Re: Request for Four Route and Corridor Changes
Northern States Power Company
Fargo-St. Cloud MN 345 kV CapX Transmission Line Siting Application
Case No. PU-07-759

156 PU-07-759 Filed 07/01/2013 Pages: 19
Application for 4 route and corridor changes
Northern States Power Company
Thomas G. Hillstrom

Fargo to St. Cloud 345 kV Transmission Line Project Reroute 1 (Maple River)

Fargo to St. Cloud 345 kV Transmission Line Project Reroute 4 (Cossette Property)

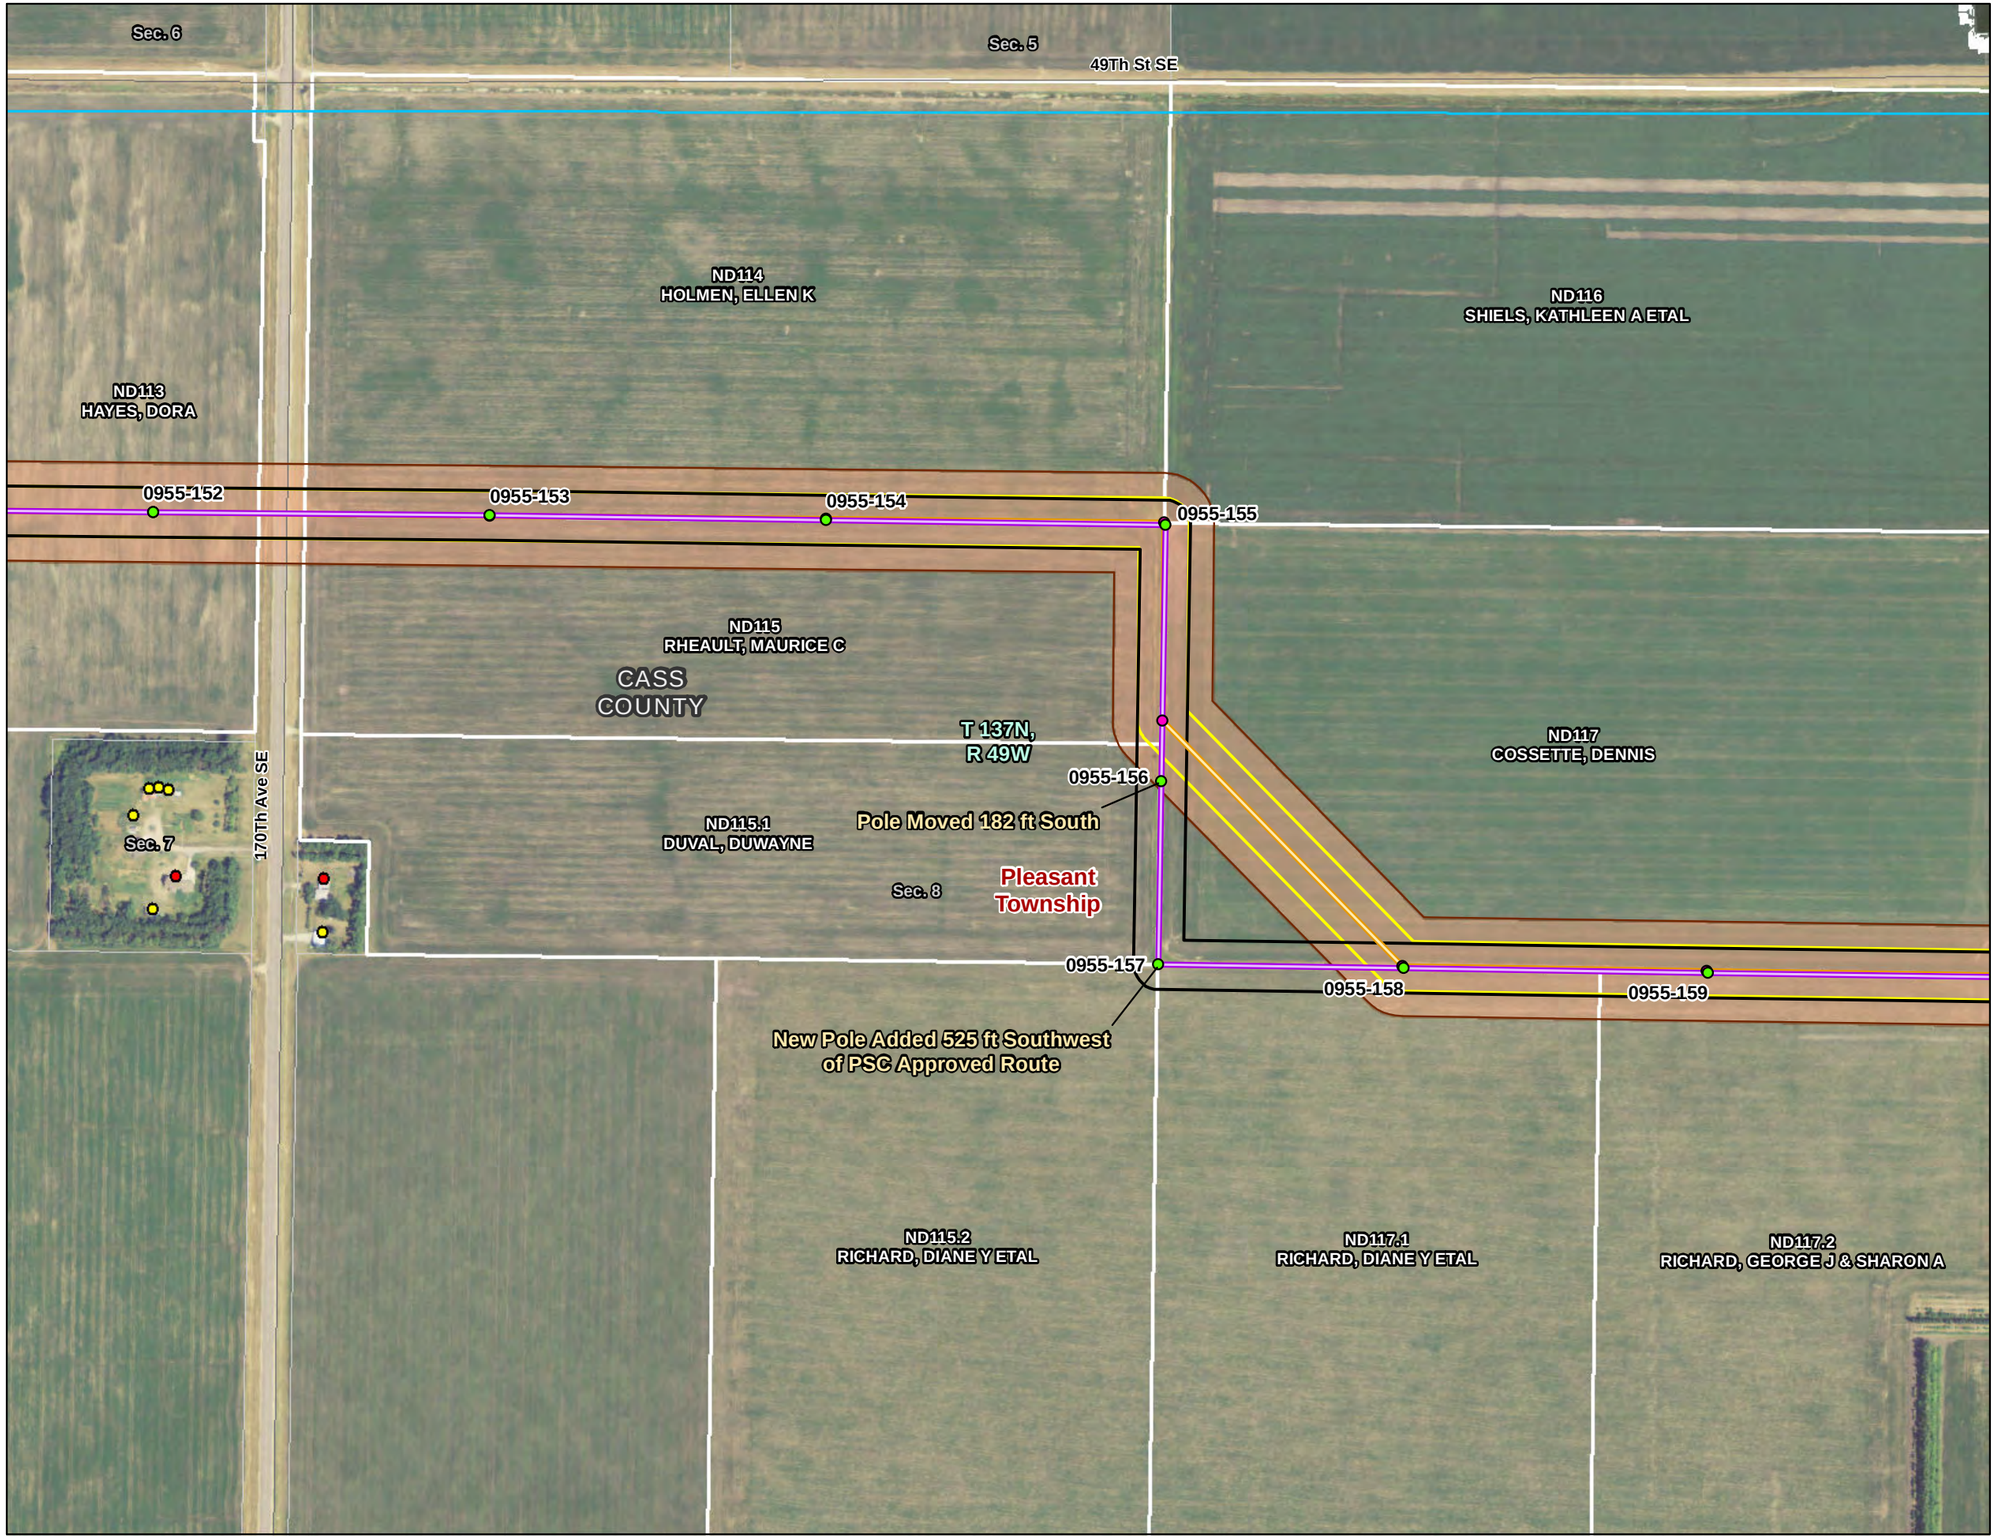
Change 4: The landowners requested a 90-degree turn on the edge of the parcel in Pleasant Township rather than a diagonal crossing to minimize impacts on farming operations. Change four adds one new pole on the corner, approximately 525 feet southwest of the route centerline, and moves one pole, 156, 182 feet to the south.

The modifications are located in Durbin, Addison, Normanna and Pleasant townships. The conditional use permits in Durbin, Addison and Normanna townships authorize Changes 1 through 3 as proposed in this filing. For Change 4 in Pleasant Township, further township review was required. On June 25, 2013 Pleasant Township approved Change No. 4. **Attachment 2**.
